This page lists the know errors on the gm5x5x5 PCBs. There are no known issues with the bulk order run (white pcbs), the following information is valid **only** for the prototype run (green pcbs).

## **Prototype Run (green PCBs)**

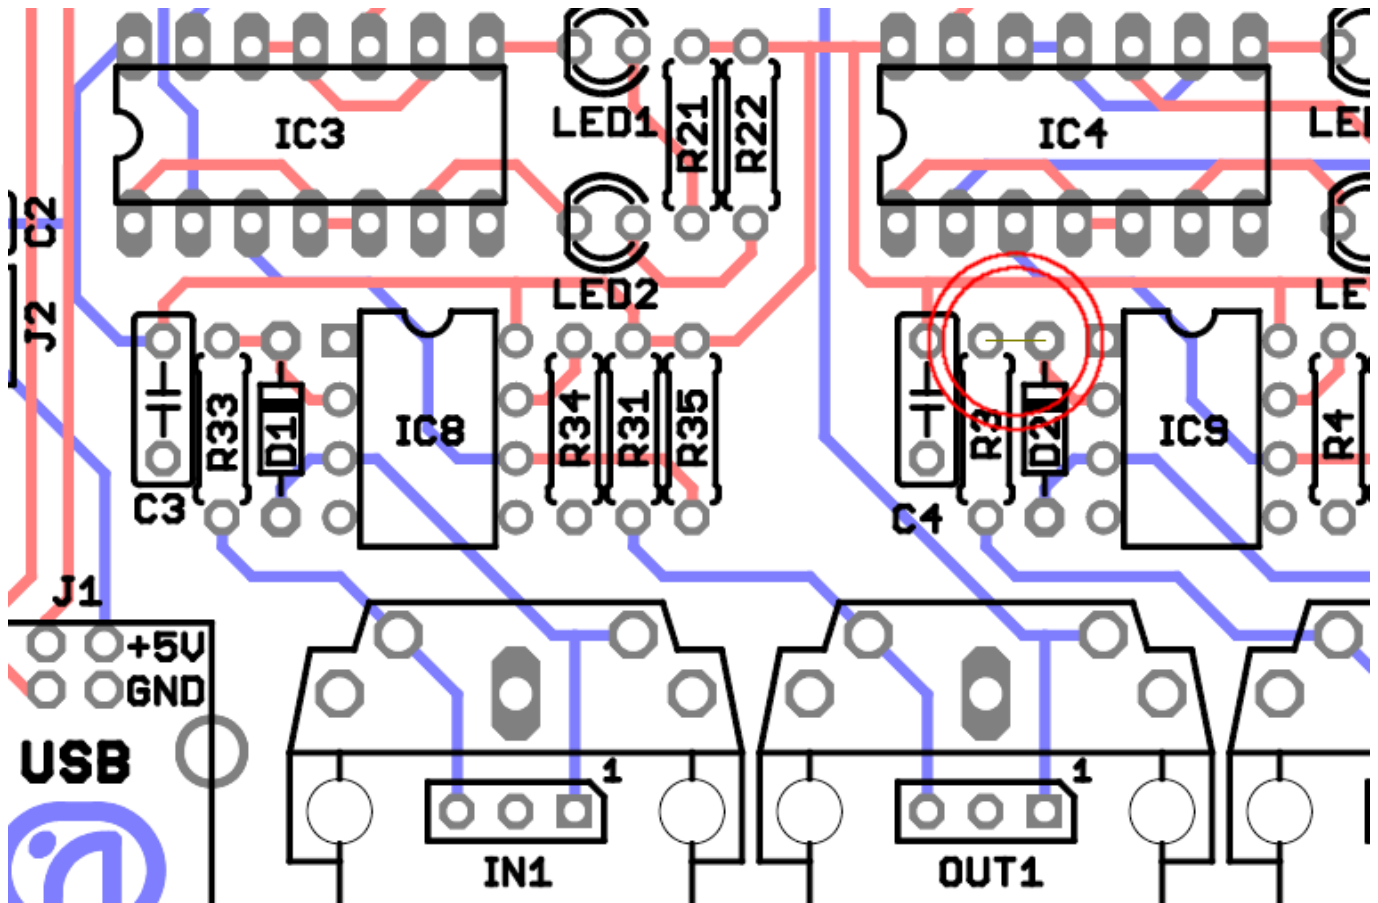
**Problem:** The MIDI IO pins of the midi sockets (Pin 4 + 5) are switched.

**Problem:** A track between D2 and R3 is missing.

**Solution:** Either (1) use the pin-headers if you use sockets that are not mounted on the pcb or (2) break the traces to pins 4 + 5 of the sockets and solder wires to them or (3) solder the midi sockets on the other side of the pcb.

**Solution:** Bridge the pins.
